### Metropolitan Development Commission Plat Committee (June 12, 2024) Meeting Agenda

PLAT COMMITTEE June 12, 2024

Staff Reviewer: Michael Weigel, Senior Planner

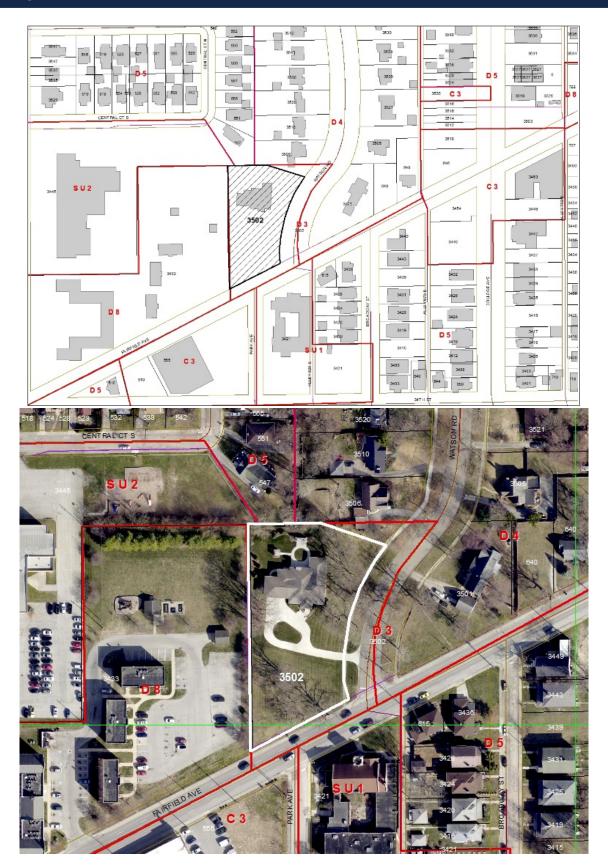
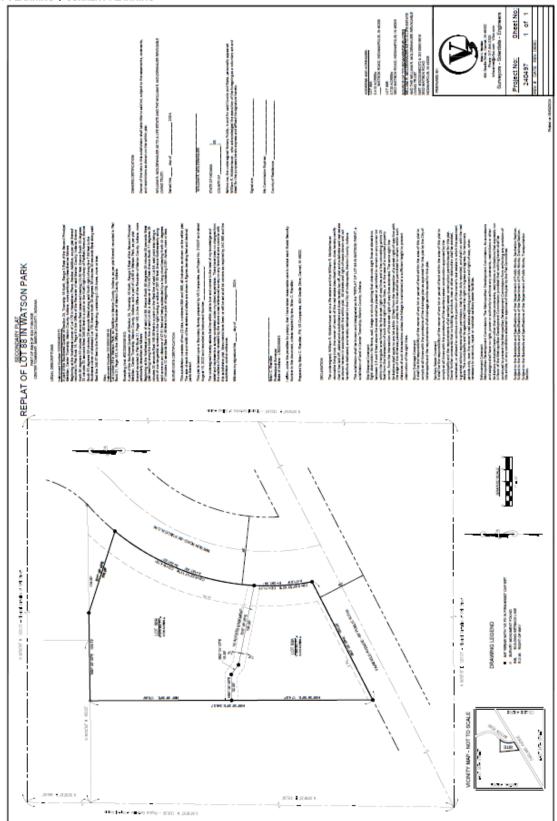
This request would replat Lot 88 in Watson Park Subdivision. The subject site is zoned D-3 and is developed with a single-family dwelling on proposed Lot 88B. This proposed plat would divide this property into two lots—Lots 88A and 88B, with Lot 88A being 0.41-acre and Lot 88B being 0.72-acre.

The petition indicates that the name of the plat would be Watson Hill, however, the plat identifies the plat name as Replat of Lot 88 and Watson Park. A condition has been added to the typical minor plat list of conditions that requests the name to match the name of the plat on the petition.

Staff recommends that the Plat Committee **approve** and find that the plat, file-dated May 15, 2024, complies with the standards of the Subdivision regulations, subject to the following conditions:

- 9. That the plat restrictions and covenants, done in accordance with the rezoning and / or variance commitments, be submitted prior to recording the final plat.
- 10. That all the standards related to secondary plat approval listed in Sections 741-207 and 741-208 of the Consolidated Zoning and Subdivision Ordinance be met prior to recording the final plat.
- 11. That the name of the plat be identified as Watson Hill on the final plat.

### 2024PLT031; Proposed Plat

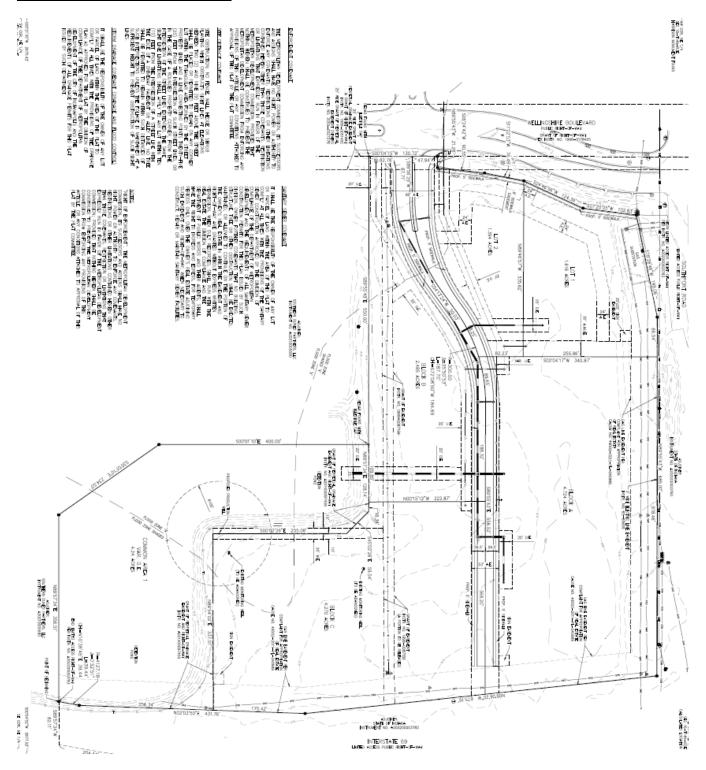
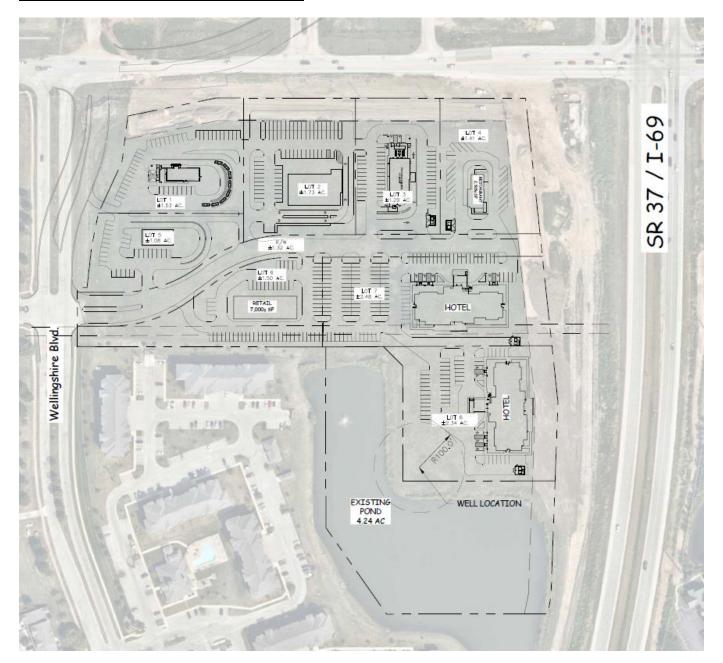
Sidewalk is either existing or proposed along Wellingshire Boulevard and would not be required along the eastern portion of the site near the interstate. The petitioner has requested a waiver of sidewalk requirements for the portion of the plat bordering Southport Road to the north (approximately 885' in length) due to what they identify as uneven grading, separation from Southport Road, and a lack of need due to interstate proximity and the placement of sidewalks along the proposed access road.

Both sides of Southport Road to the west of the subject site have sidewalks installed, as well as both sides of Wellingshire Boulevard (upon approval of the plat) and one side of Belmont Avenue to the northwest. No dramatic change in grade was noticed along the potential sidewalk area, and staff believes that increased pedestrian access to future businesses at the site would benefit both property owners and nearby residents. Sufficient evidence was not provided to justify the waiver, and staff recommends denial of the request. If the plat committee approves the waiver against staff's recommendation, a contribution in lieu of sidewalk installation should be required as a condition of approval subject to Section 744-301.G.

- 9. That the Storm Drainage Covenant (Section 741-703, of the Consolidated Zoning and Subdivision Ordinance) be affixed to the final plat prior to recording.
- 10. That the plat restrictions and covenants, done in accordance with the rezoning commitments, be submitted prior to recording the final plat.
- 11. That all the standards related to secondary plat approval listed in Sections 741-207 and 741-208 of the Consolidated Zoning and Subdivision Ordinance be met prior to recording the final plat.
- 12. That the sidewalk waiver request be denied.
